Access Compliance Report Public Rights-of-Way (Curb Ramps)

Main Street: AGAPANTHUS_ST Cross Street: PINK_TRUMPET_ST Location: SE

ADA ID: RPRK211122164931 Ramp Type: Type 4 - Parallel Initial Pass/Fail: Fail Overall Compliance: No Severity Score: 2

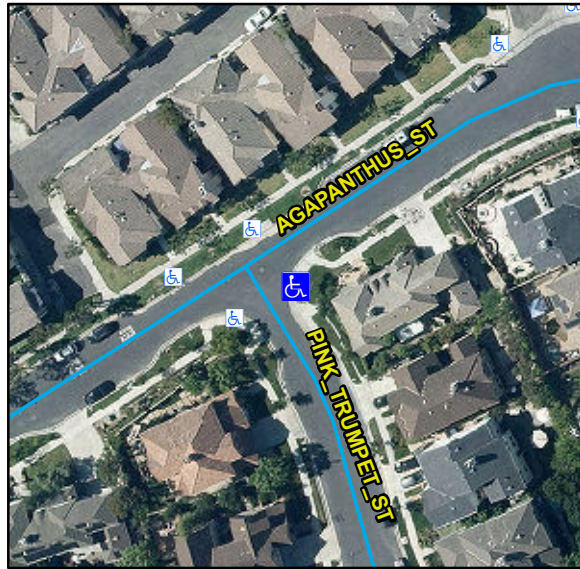
Compliance	Description	Data	Compliance	Description	Data
N/A	Ramp Length LT (in)	134	N/A	Ramp Length RT (in)	118
Yes	Ramp Width LT (in)	54	Yes	Ramp Width RT (in)	54
Yes	Ramp Run Slope LT (%)	7	Yes	Ramp Run Slope RT (%)	5.4
Yes	Ramp Cross Slope LT (%)	1.8	No	Ramp Cross Slope RT (%)	2.3
N/A	Landing Present	N/A	N/A	DWS Provided	N/A
N/A	Landing Length (in)	N/A	N/A	DWS Contrast	N/A
N/A	Landing Width (in)	N/A	N/A	DWS Length (in)	N/A
N/A	Landing Run Slope (%)	N/A	N/A	DWS Full Width	N/A
N/A	Landing Cross Slope (%)	N/A		DWS Offset Type	N/A
N/A	Landing Movement Obstructed?	N/A	N/A	DWS Offset Left (in)	N/A
	Landing Movement Type	N/A	N/A	DWS Offset Right (in)	N/A
N/A	Landing Shared	N/A			
N/A	Clear Space	Yes			
N/A	Clear Space To Crosswalk (in)	N/A			
N/A	Marked Crosswalk 1	No	N/A	Marked Crosswalk 2	No
	Crossing 1 Direction	NE		Crossing 2 Direction	NW
N/A	Marked Crosswalk 1 Width (in)	N/A		Marked Crosswalk 2 Width (in)	N/A

Remove & Replace Curb Ramp With Two New Directional Ramps or Equivalent.

R204.3, R304.5.3, STD 1115
